**SAN ANTONIO WATER SYSTEM  
CENTRAL WATER INTEGRATION PIPELINE  
TERMINUS TANK PROJECT  
SAWS Job No. 18-8609  
SAWS Solicitation No. CO-00170**

**ADDENDUM No. 3  
March 23, 2018**

**D-1302**

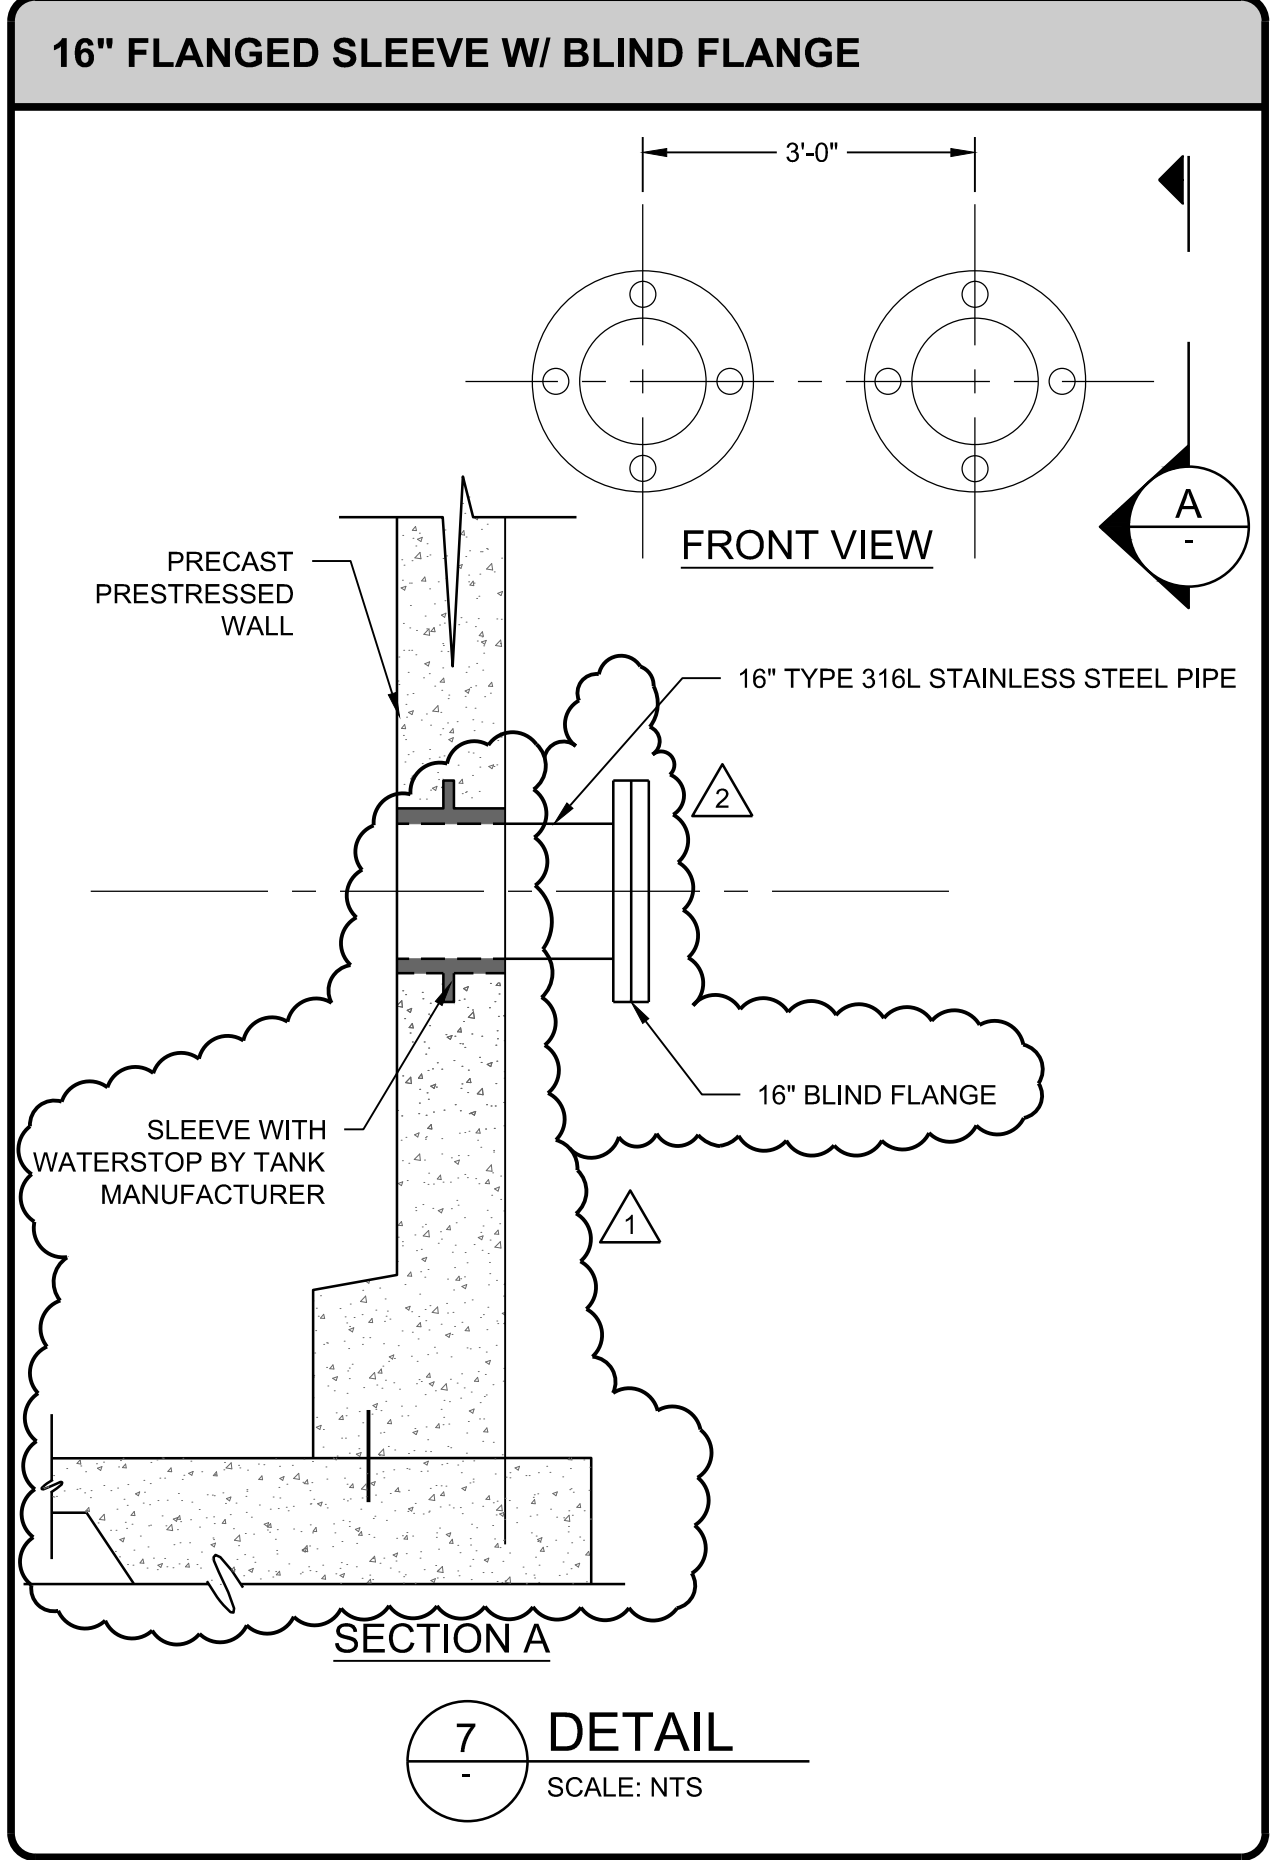
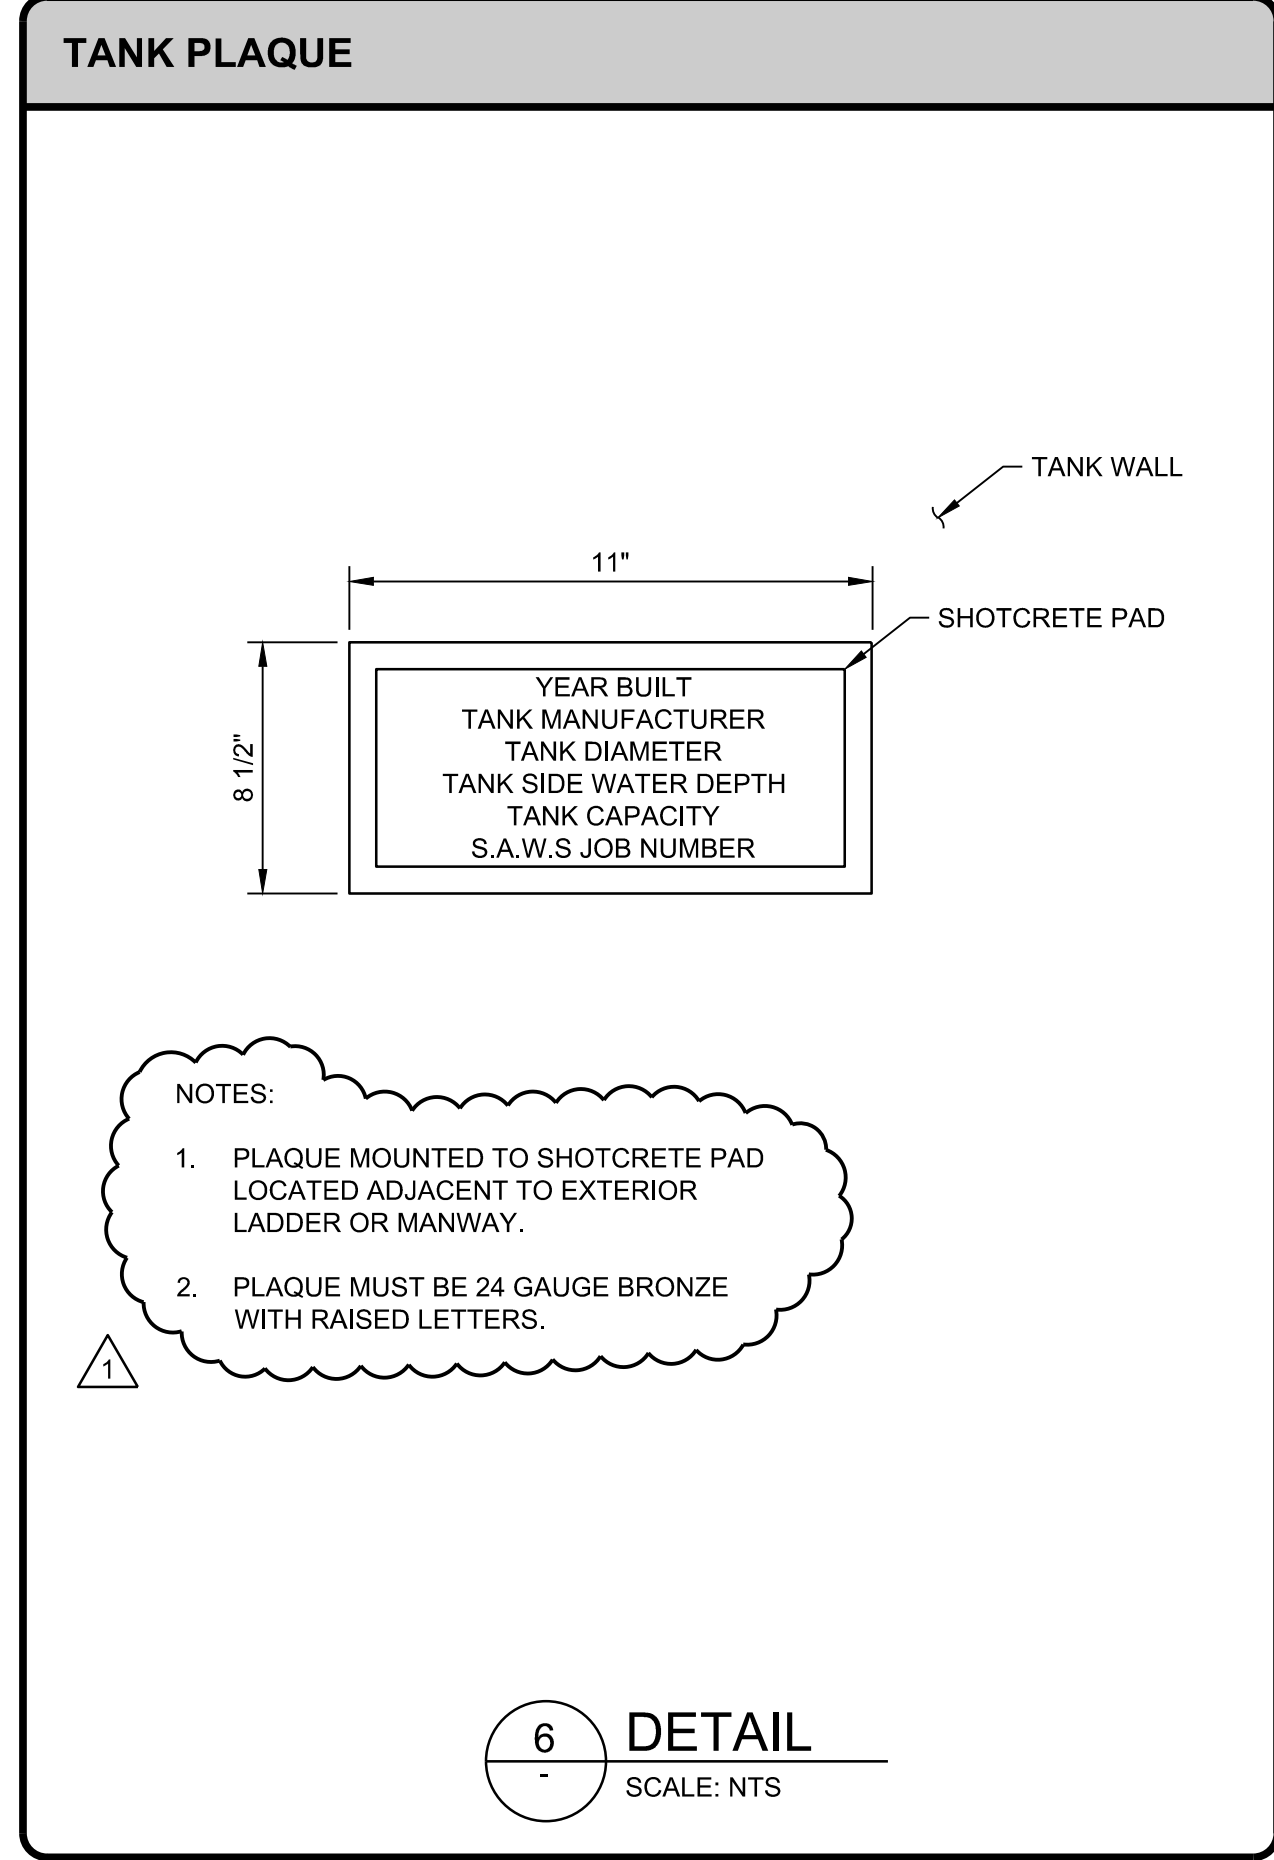
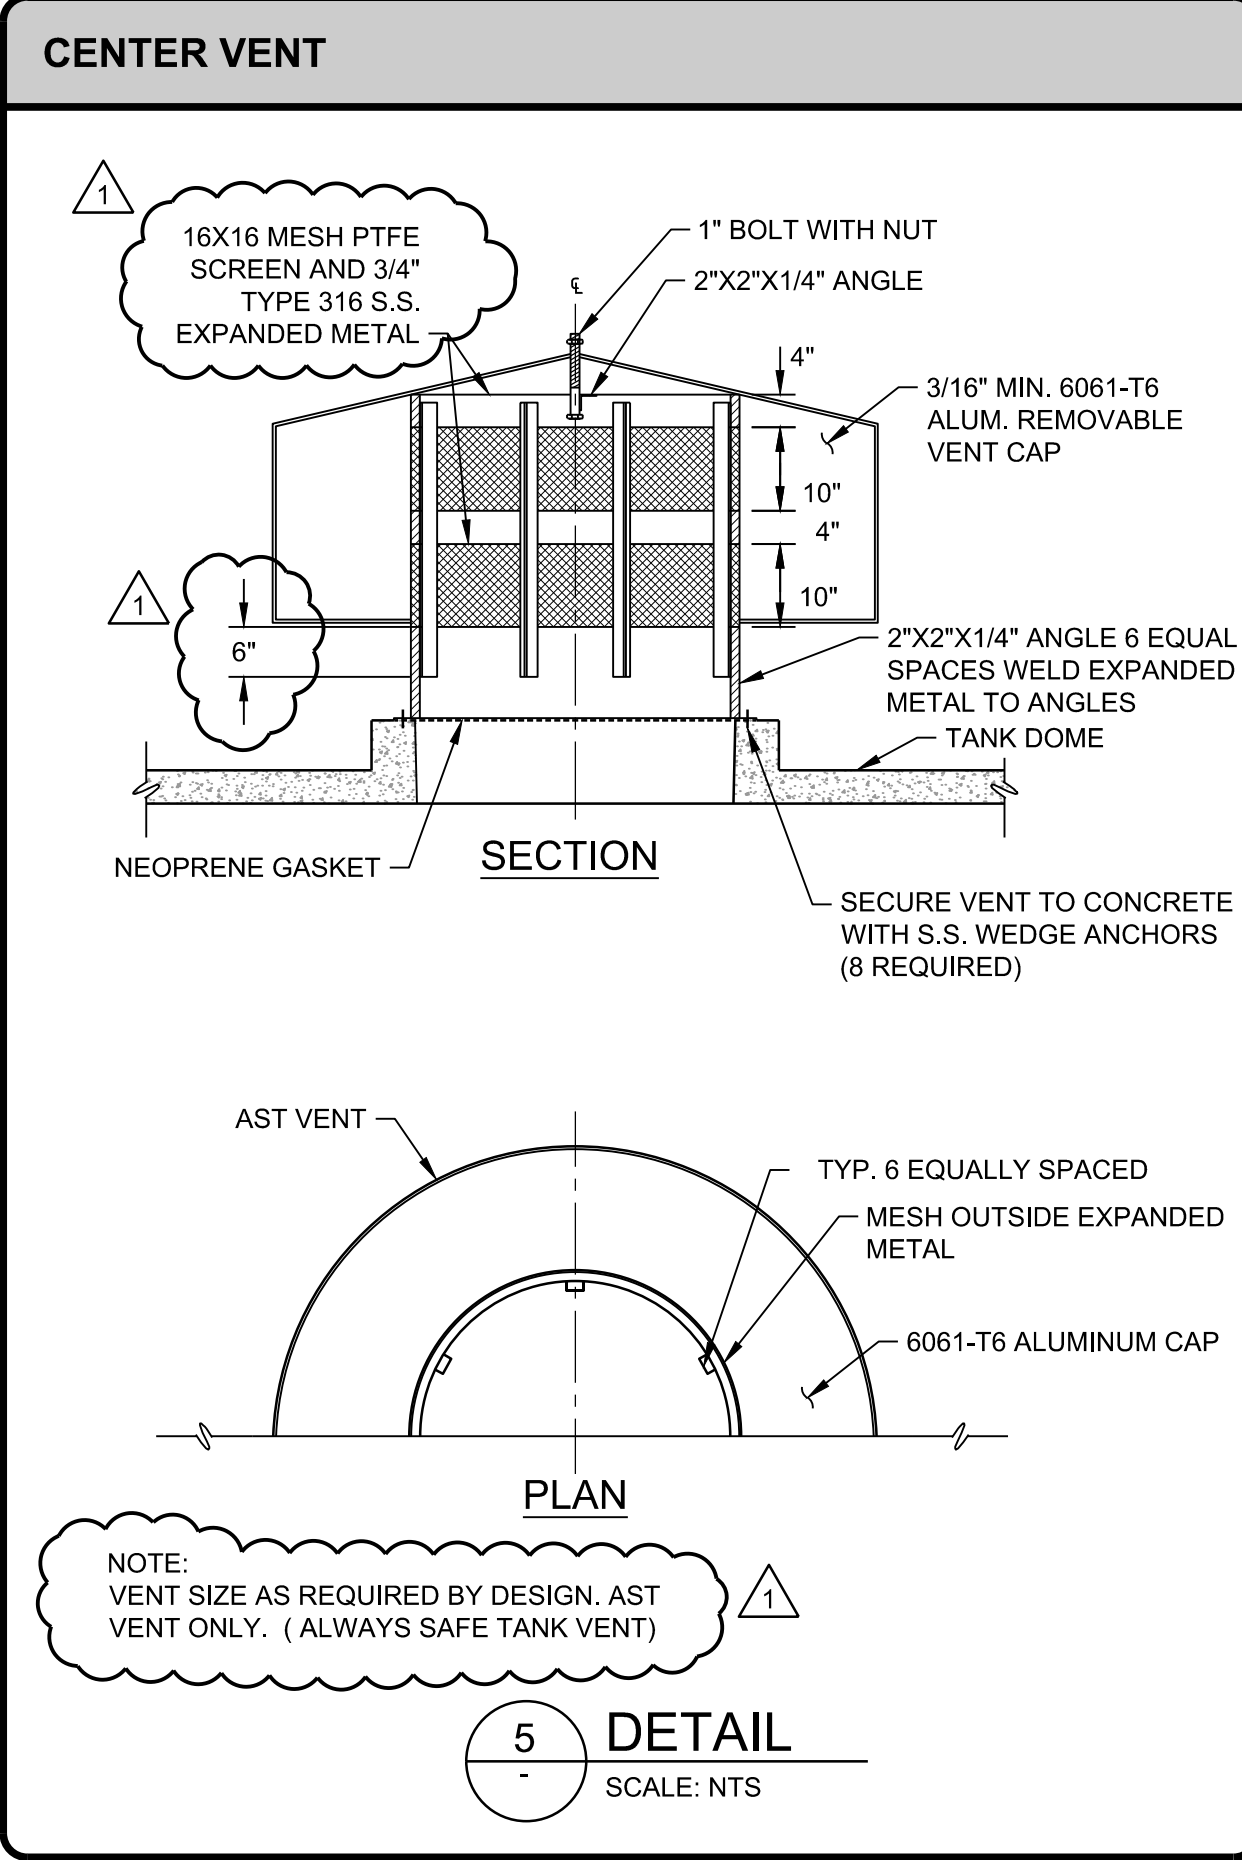
- Q7. Plans Sheet D-1302, Detail 4, indicates the use of a weir cone for the inlet riser. Typically inlet risers terminate in a plain end, please confirm if this is acceptable for this project.

- A7. A weir cone will not be installed on the inlet riser. As part of this addendum, Detail 4 (on Sheet D-1302) has been updated to show a short radius 90-degree bend (in lieu of a weir cone) at the terminus point. The invert of this 90-degree bend shall correspond to that of a plain end pipe (if it were used instead).
